خرید پکیج کولرهای هوایی ایستگاه تقویت فشار گاز بینک
(قرارداد BK-HD-GCS-CO-0015_02)

Hydrostatic Test Procedure

نسخه	سریال	نوع مدرک	رشته	تسهیلات	صادرکننده	بسته کاری	پروژه
V00	0006	PR	QC	120	AA	GCS	BK

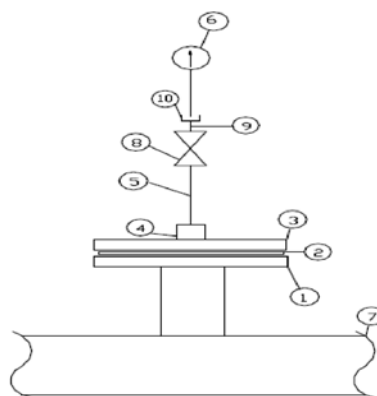
Blind Flange

Open nitrogen cylinder valve and allow dry nitrogen to flow through the system until air is removed from the system. ~~As follows~~ components shall be used & assembled as shown in following Figure 1.

AAC Reply: Noted
